Z-2-2015

Certified Recommendation

Case Information: Z-2-15 - Litchford Road/ Falls of Neuse Road

Zoning Staff Report – Case Z-2-15

Figure 3: Recommended Lane Configurations

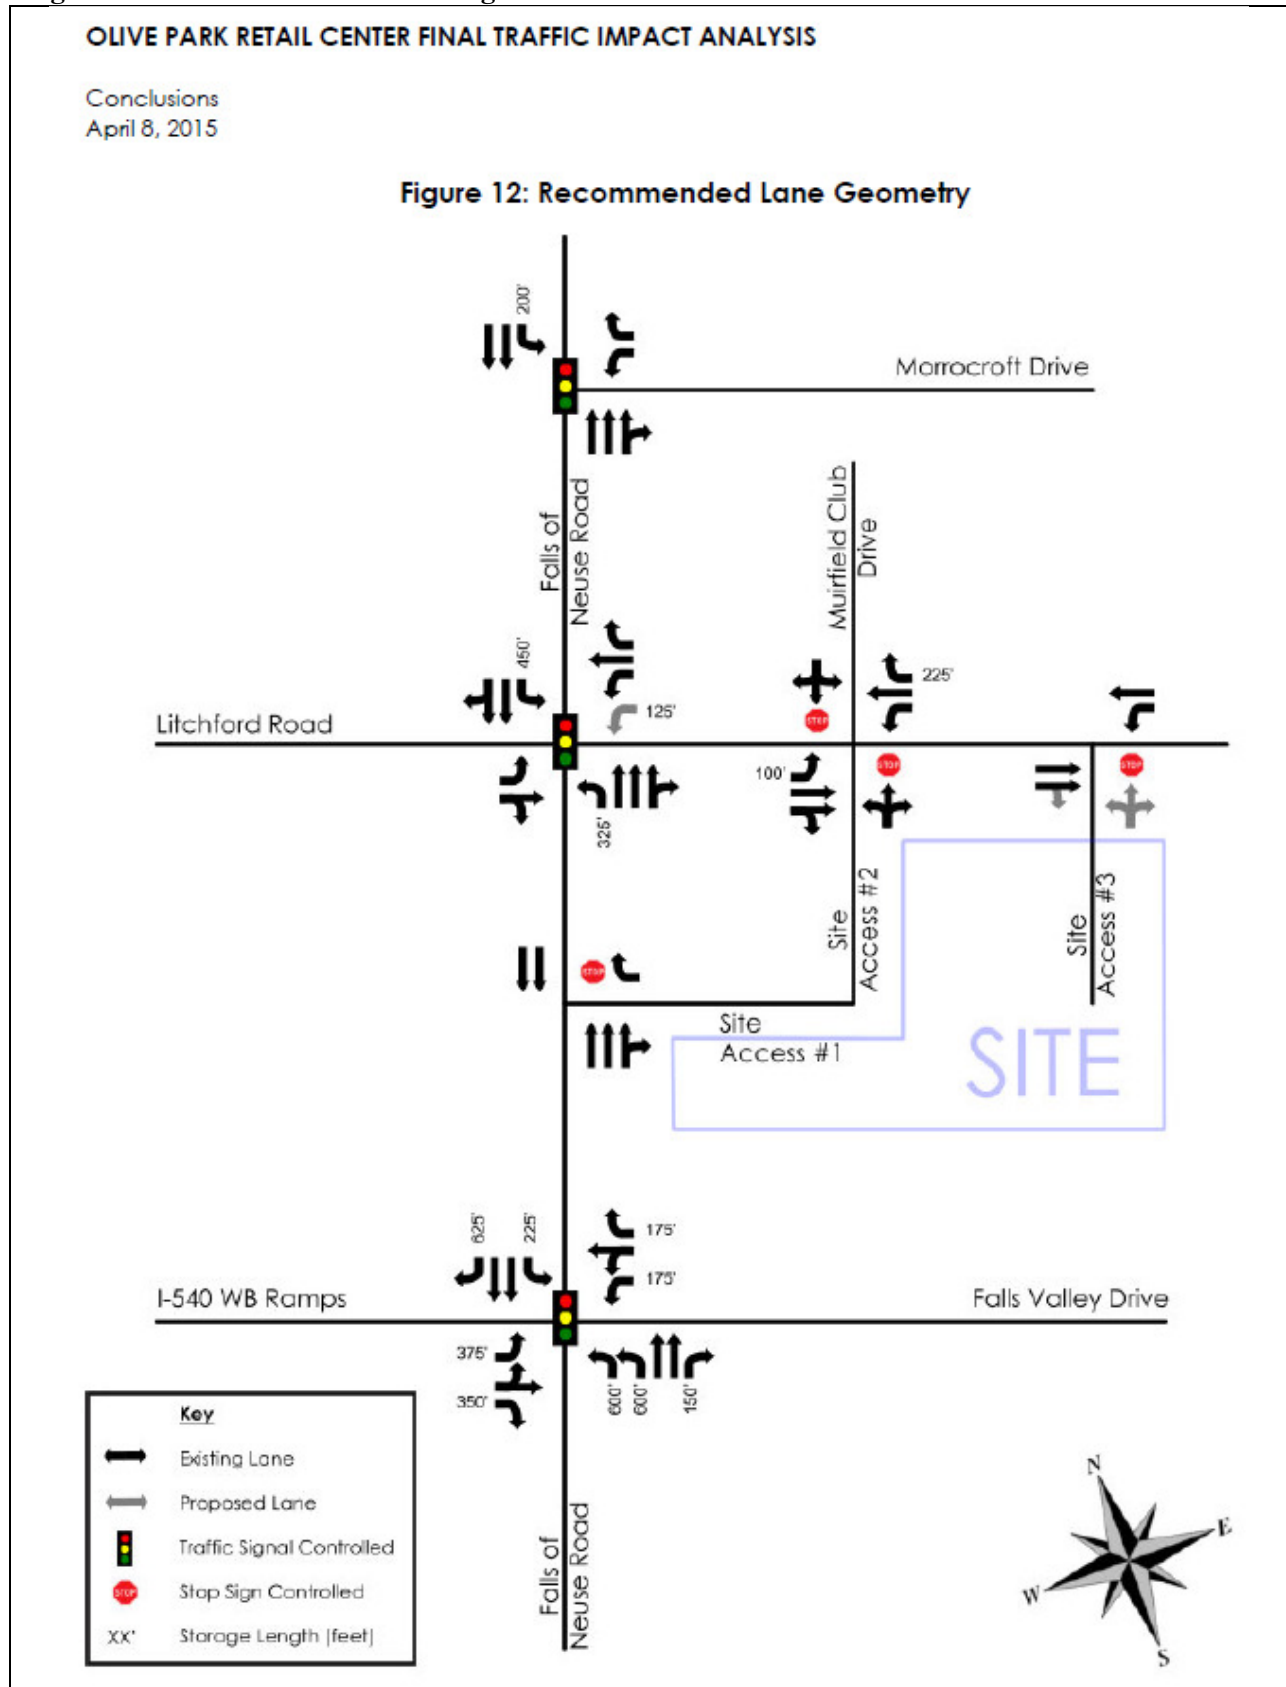
In order to reduce queuing on westbound Litchford Road, the applicant has proposed to add a second left turn lane at its intersection with Falls of Neuse. It is unclear if a second left turn lane could be added by restriping Litchford Road or if additional pavement is needed. With the additional left turn lane, the intersection of Falls of Neuse at Litchford is expected to operate at LOS-E or better during the AM and PM peak periods. No other changes to the existing infrastructure at any of the study area intersections are contemplated. Refer to Table 1 for details on delay and levels-of-service for rezoning case Z-2-2015.
